Access Compliance Report

Public Rights-of-Way

Intersection ID: 11739	Main Street: W_9TH_ST	Cross Street: N_CHURCH_ST	Location: S
ADA ID: 3E7ECD48AA33	Ramp Type: PerpDiag	Initial Pass/Fail: Fail	Overall Compliance: No
			Severity Score: 13.75

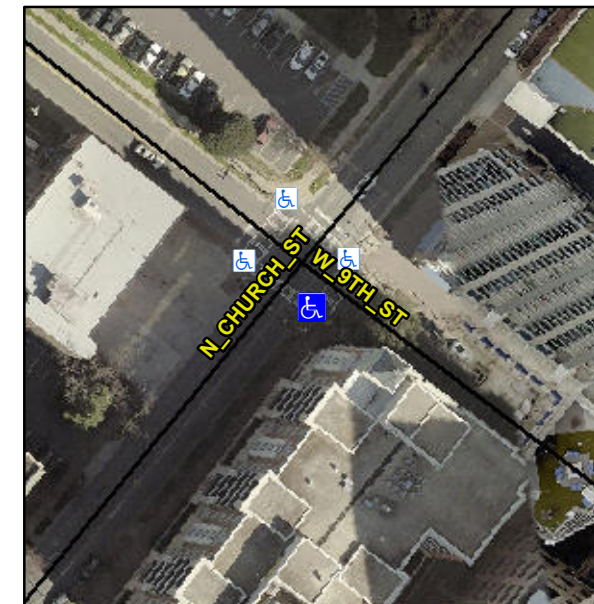
R304.2.2, R304.5.3

Compliance	Description	Data	Compliance	Description	Data
N/A	Ramp Length (in)	50.0	No	Ramp Slope (%)	8.9
Yes	Ramp Width (in)	53.0	No	Ramp XSlope (%)	4.1
N/A	Flare Type LT	N/A	N/A	Flare Type RT	N/A
N/A	Flare Slope LT (%)	N/A	N/A	Flare Slope RT (%)	N/A
N/A	Flare Traversable LT?	N/A	N/A	Flare Traversable RT?	N/A
N/A	Landing Length (in)	N/A	N/A	DWS Provided?	N/A
N/A	Landing Width (in)	N/A	N/A	DWS Contrast?	N/A
N/A	Landing Slope (%)	N/A	N/A	DWS Length (in)	N/A
N/A	Landing X Slope (%)	N/A	N/A	DWS Full Width?	N/A
N/A	Landing Curb? (Y/N)	N/A	N/A	DWS Offset (in)	N/A
N/A	Shared Landing?	N/A			
N/A	Gutter Ponding?	N/A	N/A	Gutter Slope (%)	N/A
N/A	Gutter Lip Ht (in)	N/A	N/A	Gutter X Slope (%)	N/A
N/A	Painted X Walk1?	Yes	N/A	Painted X Walk2?	Yes
	X Walk 1 Direction	To NE		X Walk 2 Direction	To NW
N/A	X Walk 1 Width (in)	110.0	N/A	X Walk 2 Width (in)	58.0
	X Walk 1 Slope (%)	2.4		X Walk 2 Slope (%)	4.5
	X Walk 1 X Slope (%)	0.3		X Walk 2 X Slope (%)	0.3

Remove & Replace Curb Ramp With Two New Directional Ramps or Equivalent.
